**STAFF REPORT**  
**COMMUNITY DEVELOPMENT DEPARTMENT**

HEARING DATE: March 8, 2022  
 TO: Mayor & City Council  
 FROM: Sonya Allen, Associate Planner  
 208-884-5533  
 SUBJECT: H-2021-0087  
 Apex West – PP (aka Pinnacle)  
 LOCATION: North side of E. Lake Hazel Rd.,  
 approximately 1/4 mile west of S. Locust  
 Grove Rd., in the south 1/2 of Section 31,  
 T.3N., R.1E.

Preliminary plat consisting of 208 building lots (207 single-family residential lots and 1 lot for future development of townhomes or multi-family apartments) and 34 common lots on 96.08 acres in the R-2, R-8 and R-15 zoning districts for Apex West Subdivision.

APEX WEST SUBDIVISION  
MERIDIAN, IDAHO  
COMMON DRIVE EXHIBITS  
BLOCK 4 LOTS 13-17 AND 24-25

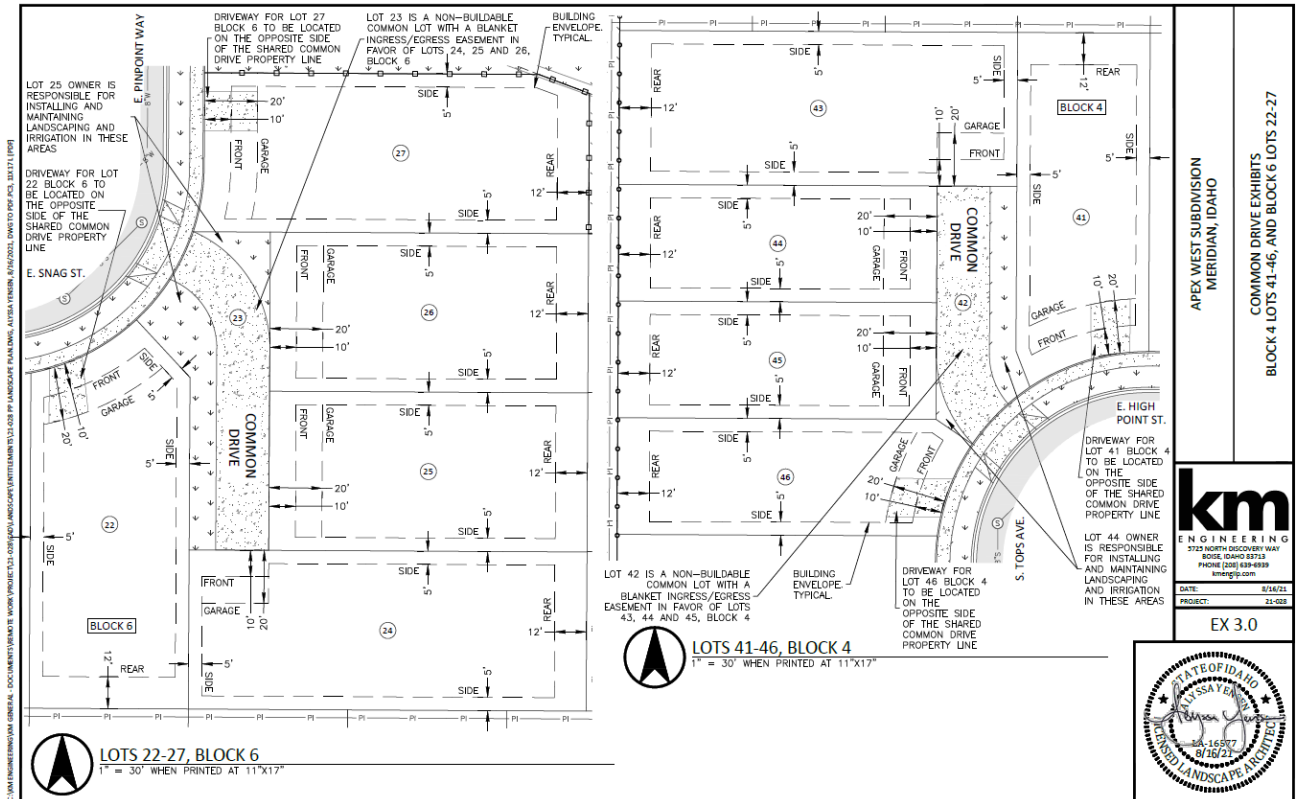
- a. Concern with the provision of (3) common driveways within the development & associated traffic congestion as discussed at the Commission hearing for Apex East; concern pertaining to parking in relation to the alley-accessed units & the adequacy of such for guests on the adjacent public streets, especially with the common driveways proposed and parking issues associated with those. Suggests some of the building lots be eliminated in favor of provision of a guest parking lot in addition to the on-street parking & elimination of the common driveways in favor of larger lots in those areas. School capacity concerns from the proposed development and others in the area.
